SAIB: CE-10-08

SUBJ: Wings: Zodiac CH601XL and CH650 Wing Structural Modifications **Date:** November 7, 2009

SAFETY ALERT / SAFETY DIRECTIVE

S.N. Number:	ZE-2009-04
Date of issue:	November 22, 2009
Subject:	Actions and upgrades from AMD Safety Alert of Sat. November 7, 2009.
Affected Models:	All Zenair CH 601 XL/CH 650 models built and operated in Europe at more than 450kg +5% (UL) and up to MTOM of 600 kg. NOTE: THIS SAFETY NOTICE DOES NOT APPLY TO ULM MODELS!
Serial Number(s):	All affected models built by CZAW or assembled from a CZAW kit. All affected models assembled from a US-made kit, up to serial #6(5)-6890
Manufactured by:	Czech Aircraft Works (CZAW) and others, from plans and/or from kits.
Purpose:	To increase safety margins and reduce the risk of accidents as a result of overloading the aircraft and to provide a process whereby operating limitations currently in place can be lifted, Zenair Europe is urging all owners and operators of affected models in Europe to upgrade their aircraft as requested by designer Chris Heintz and as outlined in the AMD Safety Alert of 11/07/2009.

ZODIAC CH 601 XL / 650	UPGRADE DRAWINGS WING SPAR & REAR CHANNEL	6-ZU-1
<small>Copyright© 2009 CHRIS HEINTZ</small>		<small>DATE: 25 JAN 2010</small>

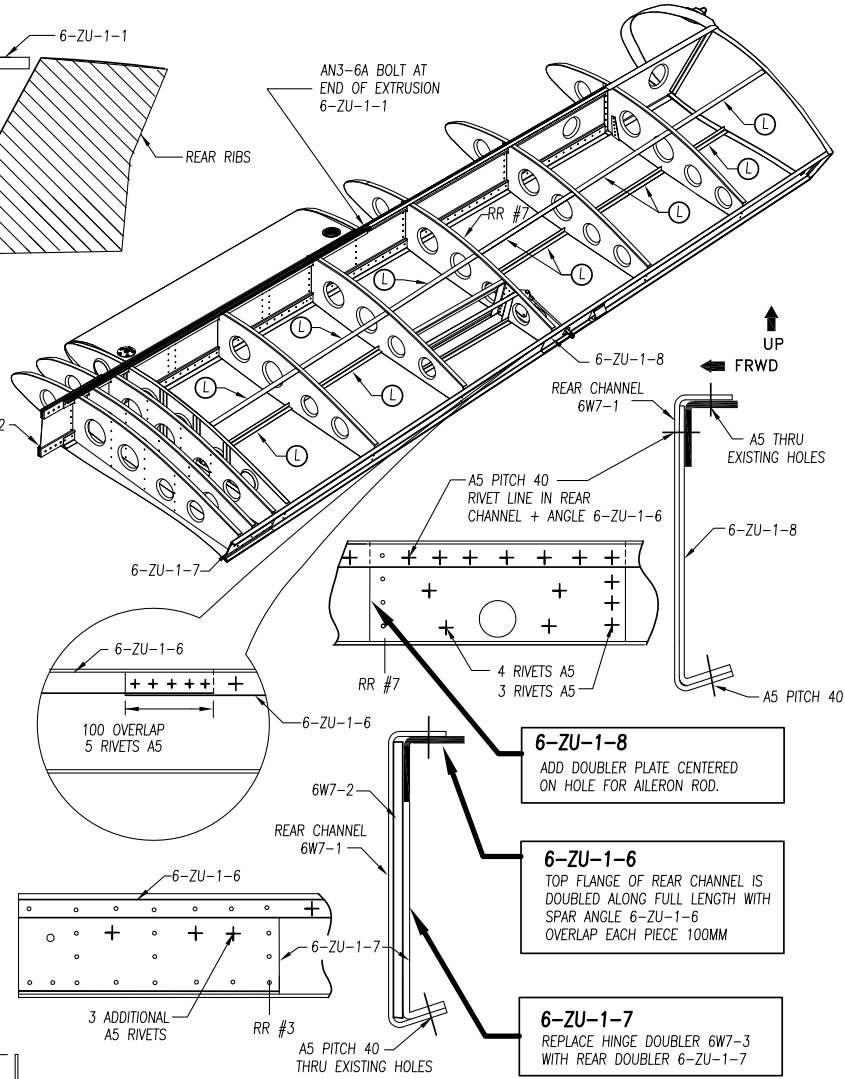
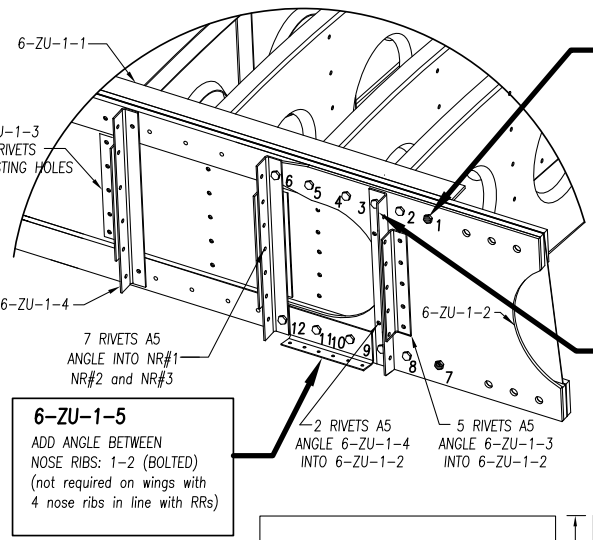
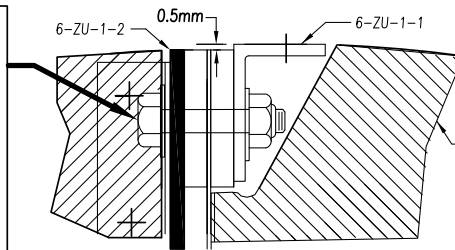
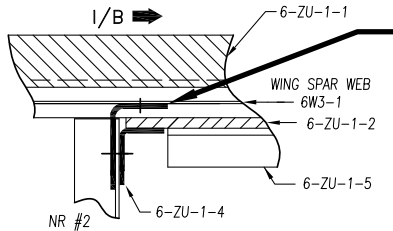
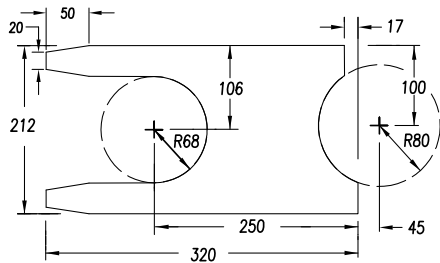
DRILL OUT SOLID RIVETS.
 CUT SPAR ANGLE 6W3-6 AT 1680MM FROM INBOARD END.
 TRIM BACK TOP FLANGE ON REAR RIBS TO CLEAR 6-ZU-1-1.
 INSTALL EXTRUSION WITH SOLID RIVETS MS20470AD-6-14 AND
 MS20470AD-6-15 (QTY=4) MS20470AD-6-10
 USE BOLTS IN ROOT AREA 6-ZU-1-2 AND ONE BOLT IN LIEU OF
 RIVET AT OUTBOARD END OF EXTRUSION.

6-ZU-1-3
 REPLACE 6W3-9 WITH 6-ZU-1-3.
 TRIM 1/8" OFF END OF NOSE RIB#1 AND 2
 RIB SANDWICHED BETWEEN 6-ZU-1-3
 AND 6-ZU-1-4. RIVET TO SIDE OF RIB

REMOVE NOSE RIB #1, #2 and #3. DRILL
 OUT BOTTOM SOLID RIVETS TO ADD
 6-ZU-1-2 ON FRONT SIDE OF SPAR.

6-ZU-1-5
 ADD ANGLE BETWEEN
 NOSE RIBS: 1-2 (BOLTED)
 (not required on wings with
 4 nose ribs in line with RRs)

6-ZU-1-4
 TRIM 1/8" OFF BACK OF NR#1
 ADD .040" ANGLE TO REPLACE 6W3-9

6-ZU-1-8
 ADD DOUBLER PLATE CENTERED
 ON HOLE FOR AILERON ROD.

6-ZU-1-6
 TOP FLANGE OF REAR CHANNEL IS
 DOUBLED ALONG FULL LENGTH WITH
 SPAR ANGLE 6-ZU-1-6
 OVERLAP EACH PIECE 100MM

6-ZU-1-7
 REPLACE HINGE DOUBLER 6W7-3
 WITH REAR DOUBLER 6-ZU-1-7

UPGRADE DRAWINGS
CENTER SPAR SECTION

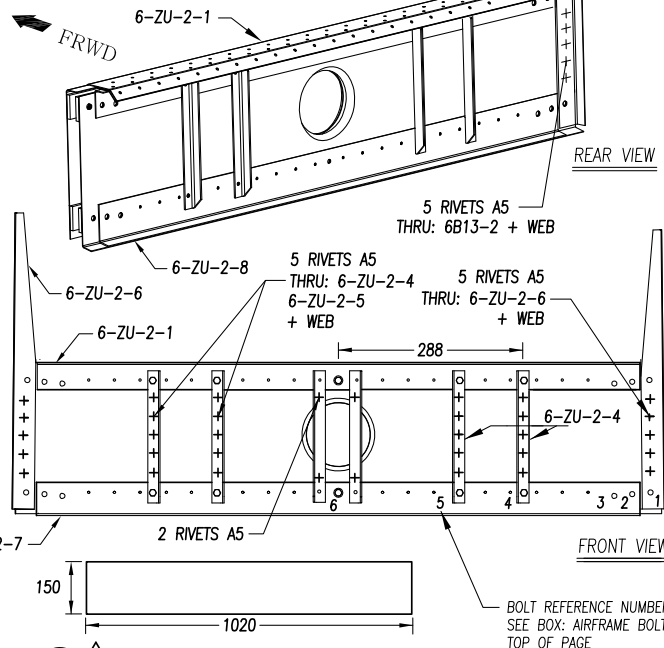
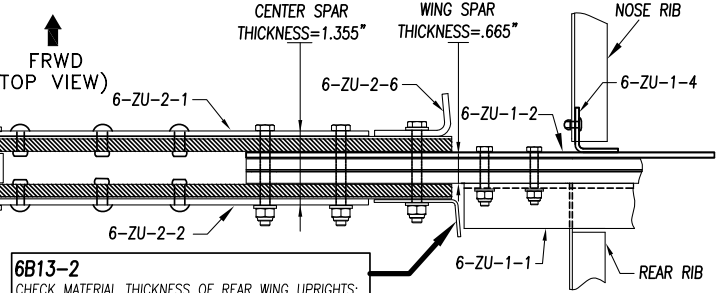
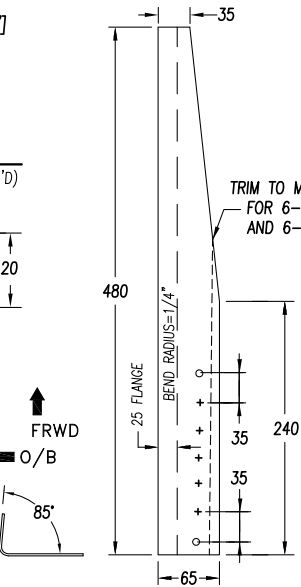
FIRST SOLID RIVET 6-ZU-2-7 AND 6-ZU-2-8 TO CAPS, ADD A FLAT PENNY WASHER AN970-4 ON EACH SIDE OF EXISTING SPACERS 6W4-5 ADD WEB SPACER 6-ZU-2-3. AND RE-ASSEMBLE WITH LONGER BOLTS.

REPLACE FRONT UPRIGHT. DRILL NEW HOLES IN FUSELAGE SIDE SKIN INTO UPRIGHT DOUBLER 6-ZU-3-5 (IGNORE EXISTING HOLES).

6B13-2
CHECK MATERIAL THICKNESS OF REAR WING UPRIGHTS:
IF t=.040" REPLACE WITH t=.063"

DRILL OUT SOLID RIVETS ADD DOUBLER ON TOP OF SPAR. RE-ASSEMBLE WITH SOLID RIVETS.
MS20470AD-5-10

UPRIGHTS OVERLAP ON TOP OF DOUBLERS INSTALLED WITH BOLTS THRU SPACER 6-ZU-2-3 RE-INSTALL UPRIGHTS 6W4-4 WITH SOLID RIVETS MS20470AD-5-11

ADD A SHIM BETWEEN WEB AND UPRIGHT. TRIM LENGTH TO FIT BETWEEN TOP DOUBLER AND BOTTOM ANGLE. RIVET UPRIGHT TO WEB.

DRILL OUT SOLID RIVETS. OVERLAP ANGLE ON FRONT SIDE OF WEB AND FLANGE. SOLID RIVET SPAR ASSEMBLY.

DRILL OUT SOLID RIVETS ADD DOUBLER ON BACK SIDE IN TOP CORNER. ASSEMBLE WITH SOLID RIVETS.

DRILL OUT SOLID RIVETS ADD ANGLE ON TOP OF WEB AND BOTTOM FLANGE. SOLID RIVET SPAR ASSEMBLY.

OVERLAP ON OUTSIDE OF FUSELAGE. REAR RIVET LINE THRU EXISTING HOLES NEW RIVET LINE THRU 6-ZU-2-7. ADD FRONT RIVET LINE

UPGRADE DRAWINGS
BELLCRANK CHANNEL - DOUBLERS

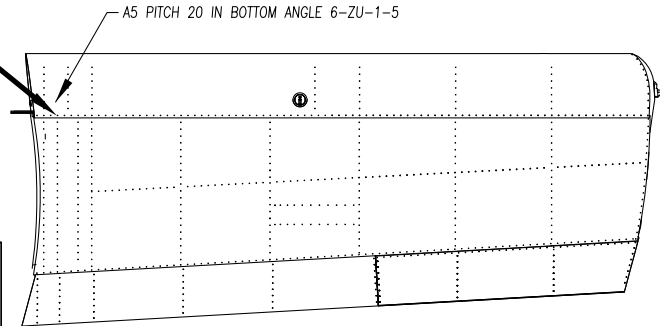
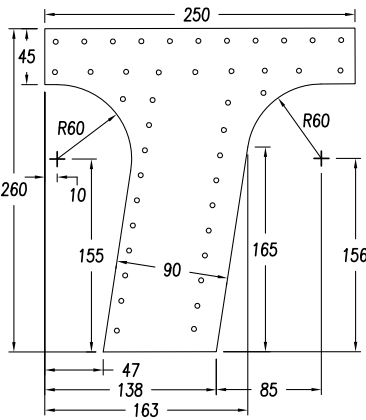
REPLACE L ANGLES ALONG SIDES OF ACCESS HOLE IN SEAT PANEL 6B15-4 WITH LONGER ANGLES 6-ZU-3-4 ALSO ADD AN ANGLE 6-ZU-3-4 IN CORNER OF SEAT PANEL AND ARM REST SIDE 6B18-1

XL ONLY - REPLACE REAR WING ATTACH PLATE 6B5-4 WITH THICKER MATERIAL 6-ZU-3-3

UPRIGHT DOUBLER OVERLAPS ON OUTSIDE OF FUSELAGE SIDE SKINS. AFT RIVET LINE THRU EXISTING UPRIGHT 6B13-2, FRONT RIVET LINE THRU 6-ZU-2-6

ADD FUSELAGE SIDE DOUBLER OVERLAPS OUTBOARD FLANGE OF GUSSET 6B10-4 RE-USE AN3-5A WITH 1 WASHER REF. DRAWING 6-B-14

DOUBLE UP RIVET LINE THRU SPAR EXTRUSION [TOP] AND SPAR ANGLE [BOTTOM] UP TO RR # 5

ADD L ANGLES BETWEEN REAR RIBS. ENDS RIVETED TO FLANGES OF BELLCRANK CHANNEL 6-ZU-3-1 RIVETED TO TOP AND BOTTOM SKINS. VIEW FRONT TOP OF RIGHT WING

REPLACE BELLCRANK SUPPORT CHANNEL 6W6-10 BY 6-ZU-3-1 REINSTALL BELLCRANK SUPPORT 6W6-11 PER DRAWINGS 6-W-6

ADD DIAGONAL STANDARD Z ANGLE TO FUSELAGE SIDE SKIN - FROM FRONT BOTTOM OF SPAR TO TOP CORNER OF VERTICAL L ANGLE AND LONGERON.

UPGRADE DRAWINGS
 CONTROL STOPS - SERVO L ANGLES

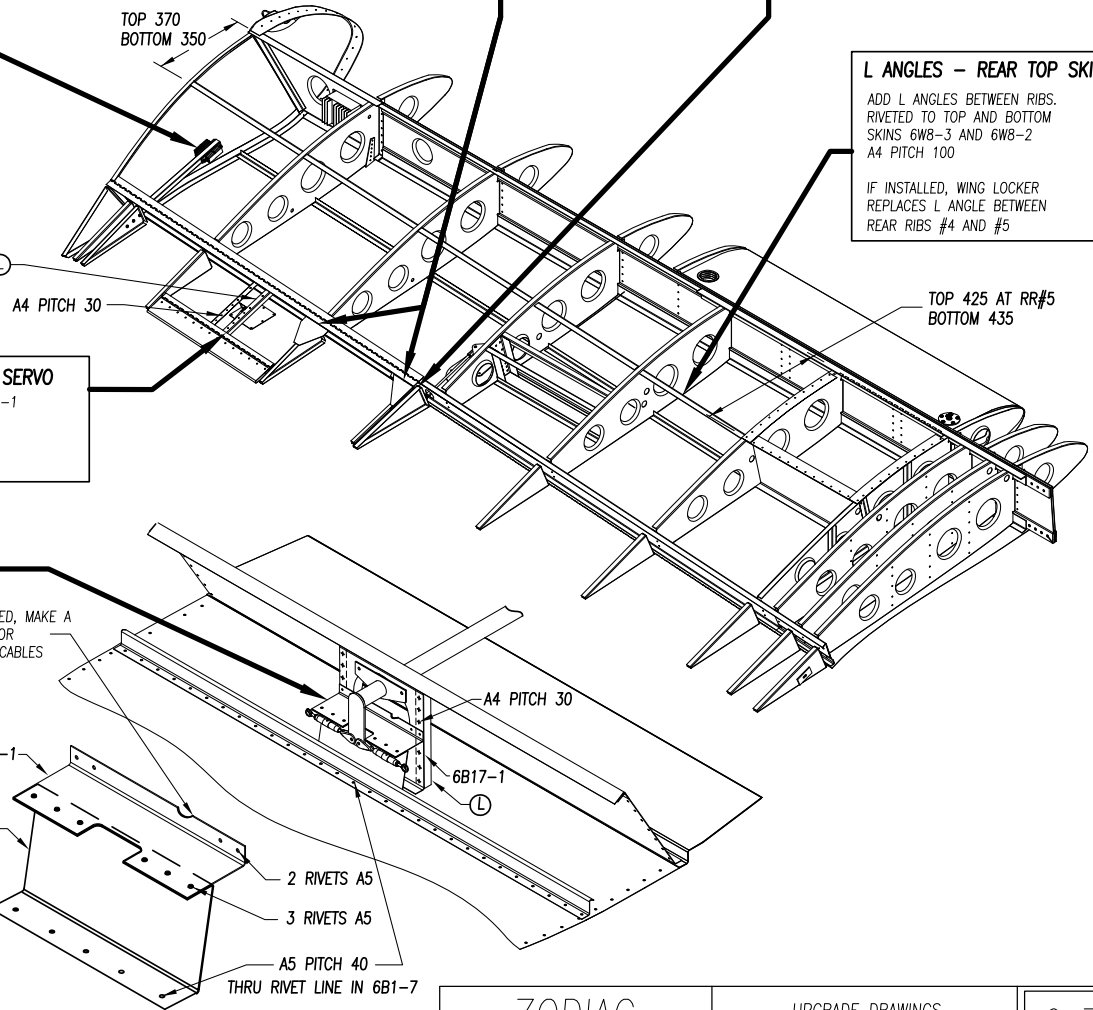
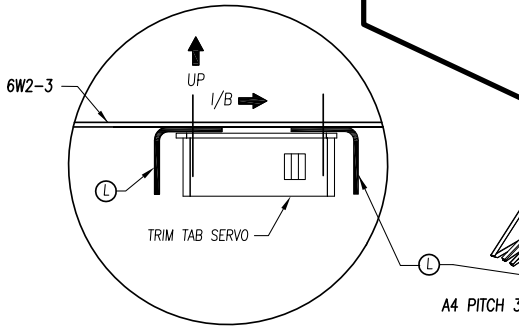
BALANCED AILERON see LAA/MOD/162B/004
 INSTALL BALANCE ARM TO AILERON RIBS
 WITH AN3-11A BOLTS AND AN365-1032 NUTS
 AILERON MASS BALANCE ALSO TO BE INSTALLED ON
 AILERONS WITH FLEX HINGE 6W2-3

REF. AILERON TRIM TAB OPTION 6-ATO-1
 ADD L ANGLES BETWEEN SERVO AND
 AILERON SKIN 6W2-3 OR 6-PH-1-1
 LENGTH=265

AILERON CONTROL STOP.
 FILE CUTOUT TO INCREASE DEFLECTION
 AS NECESSARY.

ADD AN L ANGLE TO SIDES OF
 REAR TORQUE TUBE BEARING
 SUPPORT 6B17-1

GUSSETS BETWEEN SKIN AND RIB
 65W2-5 AILERON RIB #2 GUSSET
 65W2-6 AILERON RIB #1 GUSSET

ELECTRIC FLAP ACTUATOR DRAWS FLAPS UP AGAINST
 FLAP STOPS AND SHUTS OFF AUTOMATICALLY WITH
 FLAPS UNDER LOAD. WHEN ONE FLAP IS COMPRESSED
 AGAINST ITS FLAP STOP, CHECK THAT OTHER FLAP IS
 ALSO PUSHED FIRMLY AGAINST ITS STOP.
 REPLACE ONE STOP IF NECESSARY.

ADD L ANGLES BETWEEN RIBS.
 RIVETED TO TOP AND BOTTOM
 SKINS 6W8-3 AND 6W8-2
 A4 PITCH 100
